ENGINE - FUEL AND CONTROL - PROVIDE RE-ROUTED P4.9 PRESSURE CONTROL MANIFOLDS -  
CATEGORY CODE 7 - MOD.ENG-73-0050

V2500-ENG-73-0050

Pressure control manifolds - New configuration  
Fig.1

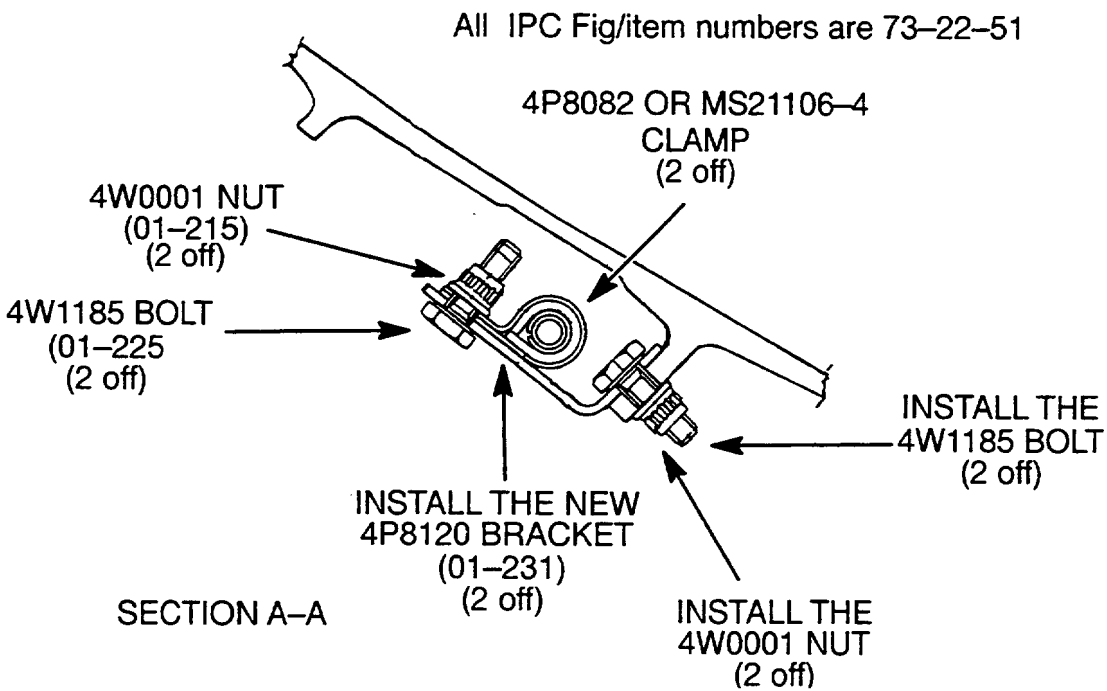
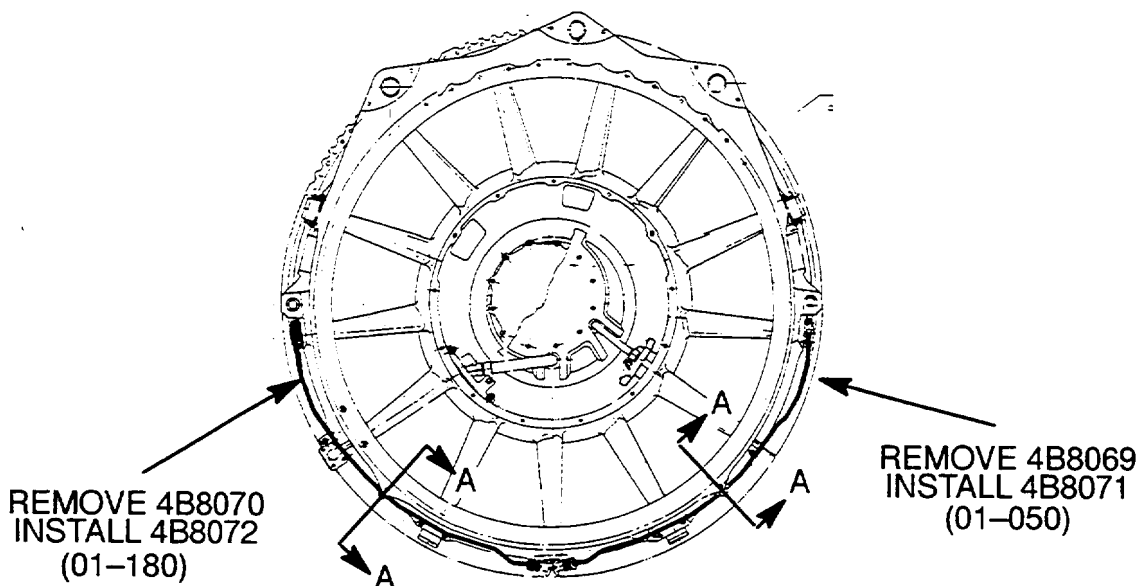
Potential of limited clearance between thrust reverser heat shield and P4.9 manifold

To provide proper clearance between the thrust reverser and P4.9 manifold.

This Service Bulletin introduce re-routed P4.9 pressure manifolds designed to proper clearance with the thrust reverser. In addition two new brackets have been added.

- (1) Install the two new 4P8120 brackets on to the TEC. See figure 1 for position and details. Install the bolts and the nuts. Torque the nuts and the bolts to 40 lbf·in (4,5 Nm.)
- (2) Install the new 4B8071 and 4B8072 pressure control manifolds by the approved procedure in Reference (3) Chapter/section 73-22-51, Removal/Installation.
